INDEPENDENT REVIEW OF 2014 DAM SAFETY INSPECTION REPORT

Snip Mine Tailings Dams

Reference Number: 1412161-004-R-Rev1-4000

Photograph 5: Weir Downstream of Dyke 1, October 1, 2014

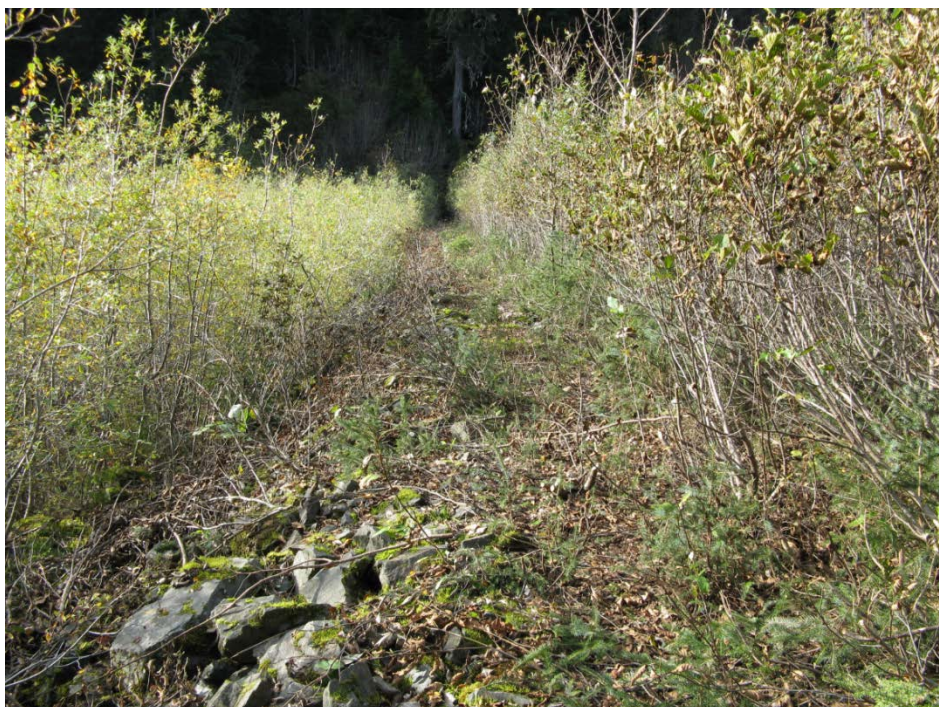
- The monitoring weir downstream of Dyke 1 is flooded. If the conditions downstream do not change in early 2015 and the weir is required for on-going monitoring, the back water condition should be investigated so the weir will operate as required (see Photograph 5 in Appendix A).
